STAFF RECOMMENDATION
1111 McKennie Avenue
February 18, 2015

Application: New construction-infill
District: Eastwood Neighborhood Conservation Zoning Overlay
Council District: 06
Map and Parcel Number: 08301028100
Applicant: Susan Hager, Architect
Project Lead: Sean Alexander, sean.alexander@nashville.gov

<p>Description of Project: The applicant proposes to construct a new two-story duplex on a vacant lot.</p> <p>Recommendation Summary: Staff recommends approval of the proposal to construct a new duplex with the conditions that:</p> <ul style="list-style-type: none">• Staff verifies that the floor height is compatible with surrounding historic houses;• The window and door selections are approved by Staff;• The roof color is approved by Staff; <p>Meeting those conditions, Staff finds that the proposal meets the applicable design guidelines for the Eastwood Neighborhood Conservation Zoning Overlay.</p>	<p>Attachments A: Photographs B: Site Plan C: Elevations</p>
--	--

SITE DIAGRAM
SCALE: 1"=20'

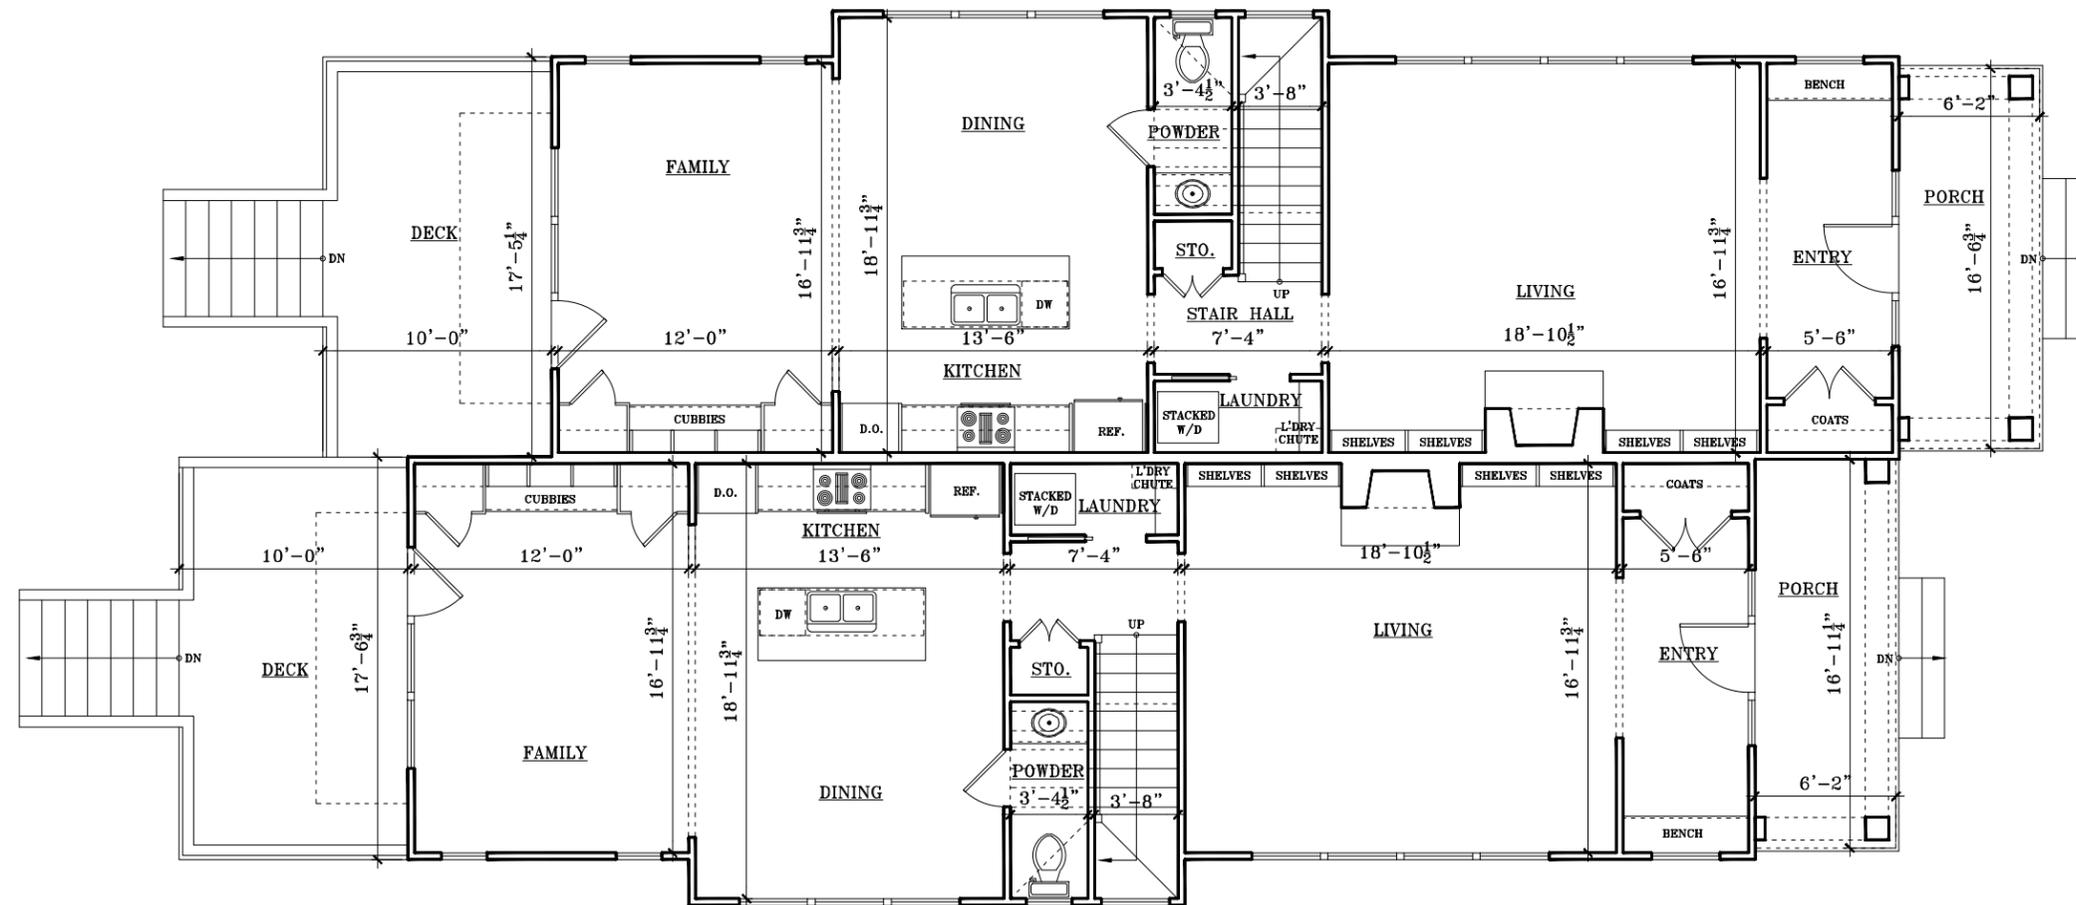
The front setback of the building will be thirty feet (30'), matching the front setbacks of surrounding historic houses. The side setbacks for the infill will be five feet (5') on each side, although from the street it will appear as though they are greater because the building is narrower at the front than at the rear.

Staff finds that the new building will maintain the rhythm of spacing established by historic buildings on the street and that the project will meet section II.B.1.c of the design guidelines.

The new building will face the street with a pair of six foot (6') deep projecting front porches with walkways leading to the right of way. A pair of uncovered paved parking pads will be constructed at the rear of the lot, accessed from the alley behind. Staff finds that this orientation of features is compatible with surrounding historic houses and that the project meets section II.B.1.f of the design guidelines.

FRONT ELEVATION
SCALE: 1/8" = 1'-0"

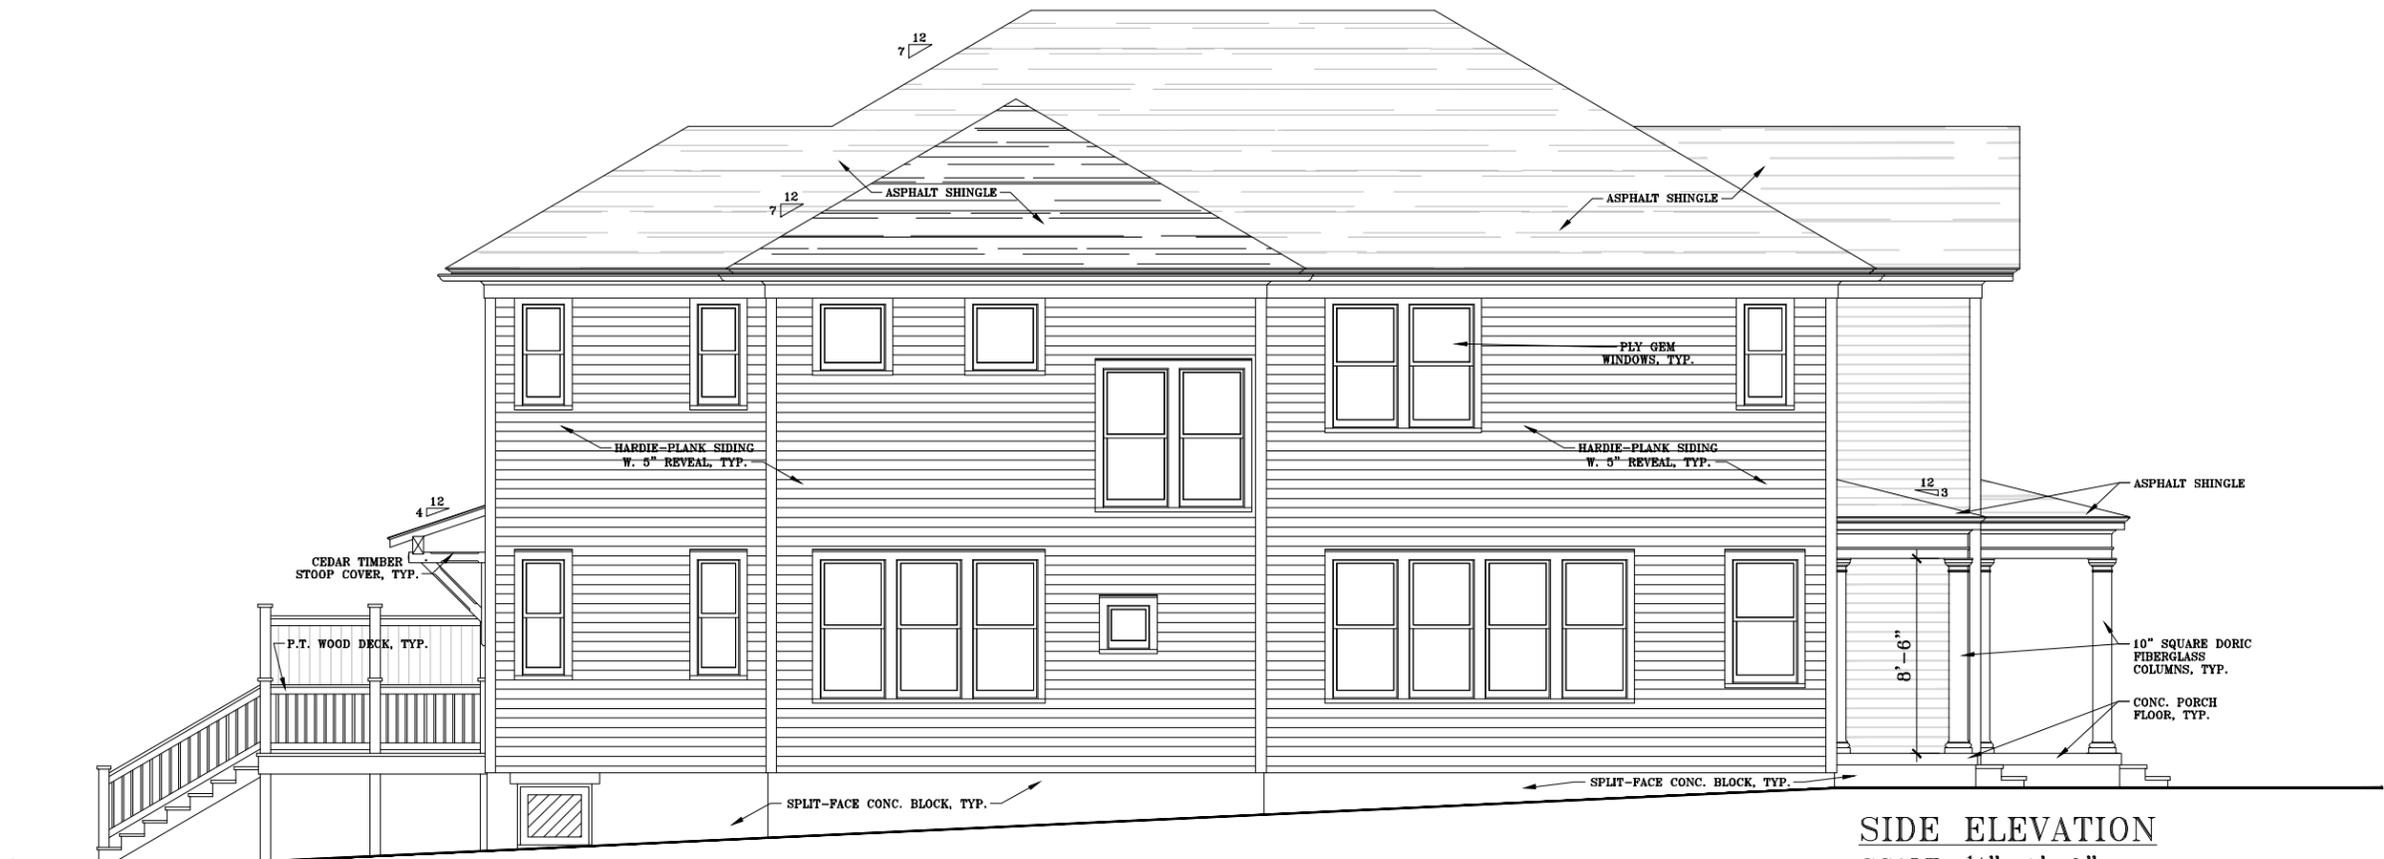
The new building will be a two-story duplex, with a hipped roof and a two-story gabled projection on the right half of the front façade. The primary roof ridge will have a height of thirty-two feet (32') above the finished floor level and the eave height will be twenty-one feet (21') above the floor level. The floor level will be approximately eighteen inches (18") above grade at the front, growing taller to the rear as the grade drops. During construction, Staff will verify that this floor height is compatible with surrounding historic houses. The new building is compatible with the heights of surrounding historic buildings which range from twenty-three foot (23') tall, one story bungalows to thirty-five foot (35') tall, two and one-half story Foursquares.

The primary massing of the building will be thirty-five feet (35') wide, with projections on each side expanding the total width to thirty-nine feet (39'). With the right half of the building projecting six feet (6') forward, the perceived width of the building at the front

The roof of the building will be hipped with a pitch of 7:12, with a gabled projection and hipped wings on both sides with the same pitch. The front porches will have a pitch of 3:12. These roofs are compatible with surrounding historic houses. Staff finds that the project meets section II.B.1.e of the design guidelines.

The windows on the proposed new building are all generally twice as tall as they are wide, thereby meeting the historic proportions of openings. There are no large expanses of wall space without a window or door opening. Staff finds the project's proportion and rhythm of openings to meet Section II.B.1.g.

- Staff verifies that the floor height is compatible with surrounding historic houses;
- The window and door selections are approved by Staff;
- The roof color is approved by Staff;
